PUFFIN II

Pre-purchase Survey

Mike Chapman,
27 Hyde Road,
Bognor Regis,
West Sussex,
PO20 4PQ

Figure 5: One of the larger blisters found on the port beam, opened up by the Surveyor.

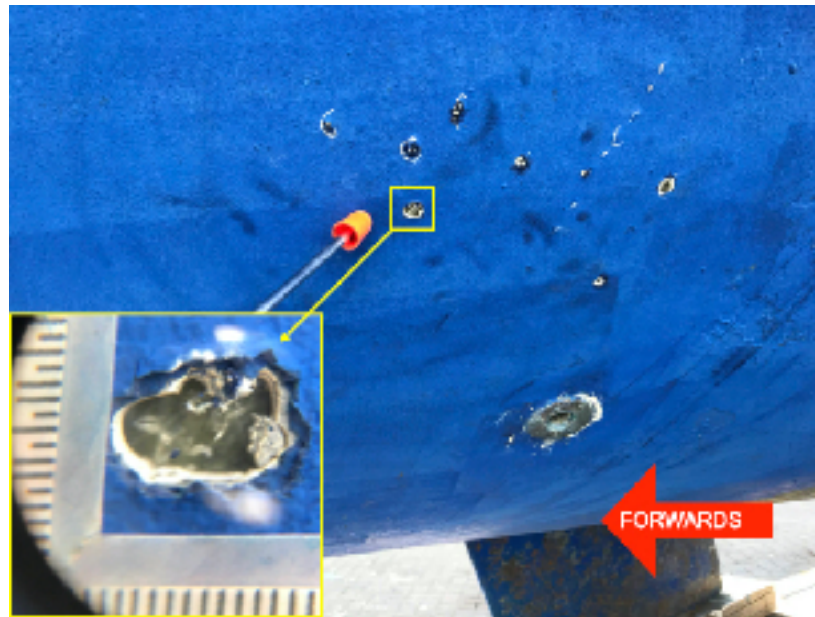
- 5.1.3.3. Small, very shallow, domed shaped blisters in the gel-coat were found to be distributed over much of the hull, with approximately 5 to 10 blisters per 200 mm square of hull area. These blisters were approximately 2 to 10 mm in diameter, but the majority were less than 5 mm in diameter. It is likely that these blisters were more pronounced when the vessel was freshly lifted. A number of the blisters were broken and opened up by the surveyor. These blisters contained a very small amount of fluid that had a foul smell but also with a faint smell of vinegar. This evidence suggests that the blisters have occurred due to hydrolysis within the hull moulding, commonly termed as 'osmosis'. The glass fibres within the inspected blisters were well coated with resin. Figure 5 shows an example of one of the larger blisters. None of the opened up blister

cavities were deep, indicating that the blisters had developed just beneath the gel-coat. Referring to the publication 'Repairs to Blisters in Glass Fibre Hulls [British Plastics Federation, October 1984], these blisters are of type 3B. This type of blister leaves the laminate more susceptible to the ingress of moisture. Whilst not of immediate significance to the integrity of the hull, to leave blisters of this type to develop over a number of years could lead to a localised weak area in the hull. Development of more blisters of this kind can not be ruled out and the size of the existing blisters may increase in size. It is **RECOMMENDED** (type C recommendation with an implementation time of one year) that all blisters greater than 5 mm in diameter are broken open and the cavity cut back to sound laminate. The laminate should then be thoroughly cleaned & dried. If the cavities are deep, the exposed surfaces should then be repaired layers of GRP cloth and finished with a gel-coat. If the cavities are shallow they can be filled with epoxy filler.

Figure 6: Location of skin fittings (plan view looking from above)

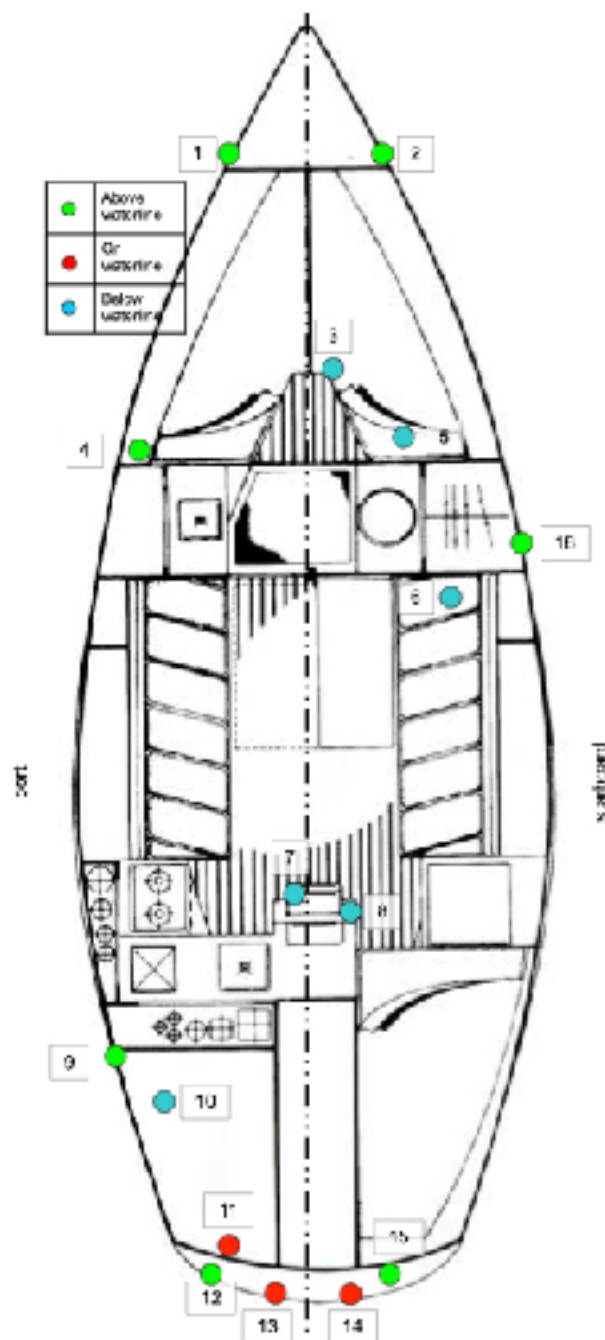
- 5.1.8.4. The skin fittings were all in serviceable condition, but the plywood backing plate of the heads sink outlet and heads toilet inlet (items 4 and 5 in Figure 6 and Table 3) were found to be rotten and loose. These backing pads help to support the hull in the region of the skin fittings, protecting the GRP from any lateral loads that might be applied to the isolation valve. It is **RECOMMENDED** (type C recommendation with an implementation time of six months) that these backing pads are replaced. All other plywood backing pads should be regularly checked and replaced if these are found to be rotting.

- 5.1.8.5. The plastic skin fitting of the cabin heater exhaust (item 12 in Figure 6 and Table 3) had melted. The stainless steel exhaust pipe of this unit was not clamped to the body of the heater with any hose clip or pipe clamp. Refer to section 5.6.6 for details of the recommendation relating to the LPG fuelled space heater.

- 5.1.8.6. The PVC skin fitting of the manual bilge pump outlet (item 15 in Figure 6 and Table 3) was currently in serviceable condition, but the exposed parts were found to be weakened due to UV exposure. It is **RECOMMENDED** (type C recommendation with an implementation time of two years) that this skin fitting is replaced.

- 5.1.8.8. All valves must be regularly exercised in order to prevent them from seizing. The isolation valves of the heads inlet and heads outlet (items 5 and 6 in Figure 6 and Table 3) were seized in the open position. It is **RECOMMENDED** (type C recommendation with an implementation time of one week) that that these valve are un-seized. If they do not free up adequately, the valves should be replaced.

- 5.1.8.13. The hoses of the cockpit drains and manual bilge pump (items 13, 14 and 15 in Figure 6 and Table 3) were very old and have hardened with age. It is **RECOMMENDED** (type C recommendation with an implementation time of two to three years) that these hoses are replaced.

- 5.1.8.14. The hoses for the heads sink outlet, heads toilet inlet and two cockpit drains (items 4, 5, 13 and 14 in Figure 6 and Table 3) were located close to or below the waterline and were only secured with a single stainless steel screw clip. It is **RECOMMENDED** (type A2 recommendation) that where the hose tail of the valve or skin fitting is long enough to accept two clips, all hoses that have a skin fitting located near to or below the waterline should be fitted with two hose clips at each end. These clips should be manufactured from marine grade stainless steel. This recommendation also applies to the clips that attach the hoses to the toilet in the heads compartment.

Figure 8: Isolation valve & hose of engine cooling intake

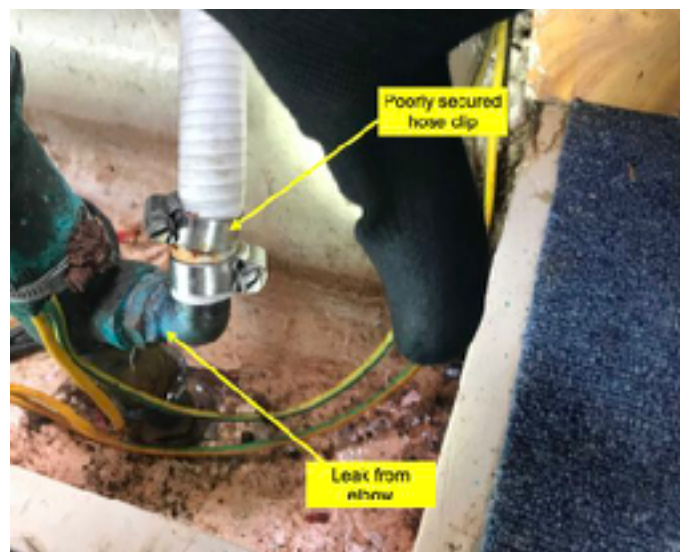
- 5.1.8.9. During the engine & transmission test on Friday 24th August, it was found that the isolation valve of the engine cooling intake (item 7 in Figure 6 and Table 3) was leaking at a rate of eight drips every ten seconds. The location of the leak can be seen in Figure 8. It is **RECOMMENDED** (type A2 recommendation) that this leak is rectified.

- 5.1.8.12. The hose of the engine cooling intake (item 7 in Figure 6 and Table 3) was secured to the isolation valve with two stainless steel hose clips. One of these clips was poorly secured and was not gripping on the hose tail of the isolation valve. This hose clip can be seen in Figure 8 It is **RECOMMENDED** (type A2 recommendation) that both hose clips are correctly secured.

Figure 9: Worn bearing surfaces of gooseneck

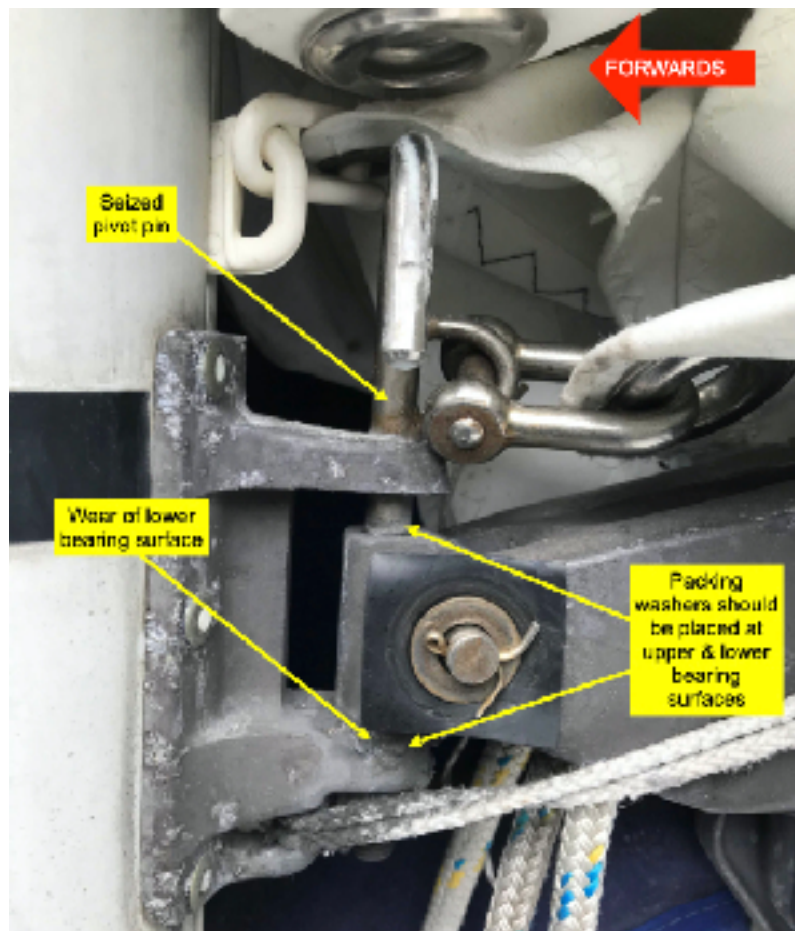
- 5.4.1.3. The Proctor boom was in good condition, with no significant wear of the anodised coating. The cast aluminium gooseneck was in poor condition. The rivets that secured the castings to the mast and to the boom were secure and free of damage. The vertical stainless steel pivot pin was seized. There was a large gap between the bearing surfaces of this vertical pivot, with significant wear of the lower bearing surface. These defects are shown in Figure 9. It is **RECOMMENDED** (type C recommendation with an implementation time of six months) that the seized pivot pin is released. The gooseneck should be disassembled and all parts cleaned & lubricated. The excessive play in the pivots should be taken up by a combination of nylon and stainless steel washers.
